MEMORANDUM

To: Design Review Board
From: Tony Leavitt, Senior Planner
Date: August 29, 2018
File No.: DRV18-00493
Subject: **ROSE HILL MIXED USE PROJECT CONCEPTUAL MASTER PLAN AND PROJECT DESIGN RESPONSE CONFERENCE**

Design Response Conference
Submittal #1 - DRV18-00493
August 27, 2018

CONCEPTUAL DESIGN CONFERENCE CONCEPTS

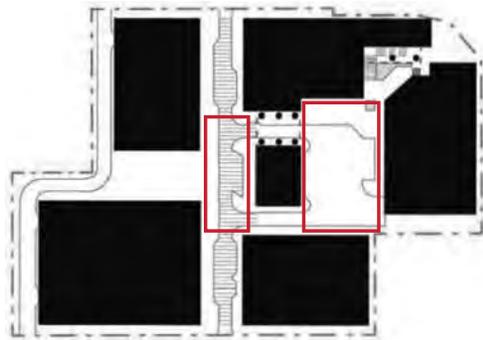
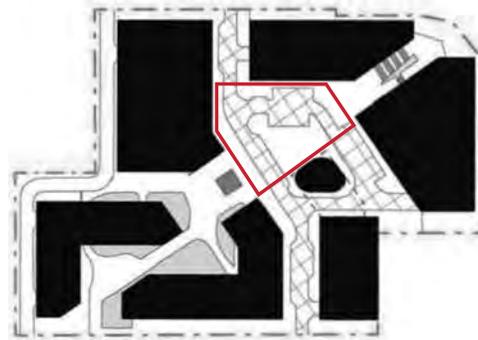
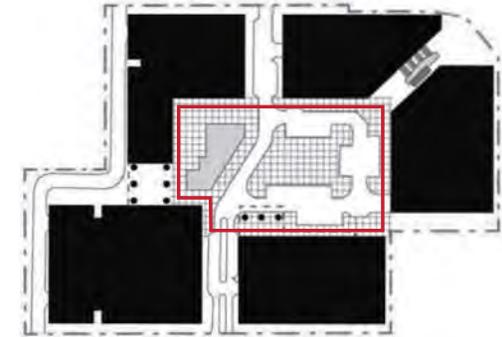
The DRB expressed a preference for massing Option 2, the “Hub” (the applicant’s preferred design). The DRB requested the following items for submittal:

- Impacts from the height of structure as viewed from the properties to the north.
- Increase modulation along 120th and 122nd Avenues.
- Ensure that the project design activates all adjoining right-of-ways and does not turn inward.
- Along NE 85th, look at providing food services as part of the grocery store.
- Treatment of large wall adjoining the U-Haul property.
- Residential uses at the ground floor should be encouraged along the sidewalks at both 120th & 122nd. Supporting Design Guidelines

As requested by the DRB, the applicant has provided detailed plans of massing Option 2 for review (see Attachment 2). Additionally the applicant

has revised the design to incorporate some elements of the Piazza Design (Option 3 from the CDC meeting)

SUMMARY OF CDC COMMENTS

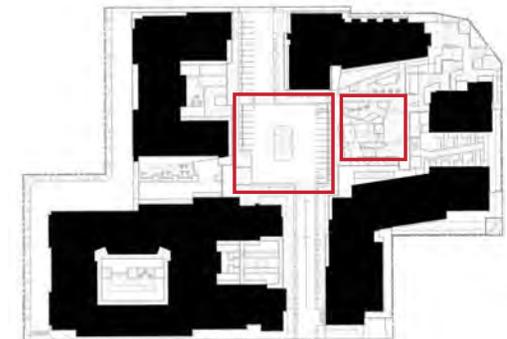
- Height of structure when viewed from the North.
- Interior of plaza should not be complex.
- Food services from grocery could engage 85th, activation is important.
- Entrance to U-Haul should not be too abrupt from 85th.
- Long walls along 120th and 122nd should be modulated.
- Travel through the site should be clear and friendly.
- We are encouraged to have the project face both inward and outward.
- Residential uses at sidewalk should be encouraged along 120th and 122nd.
- Strong interior plaza form is positive.
- Sun exposure to interior spaces is important.
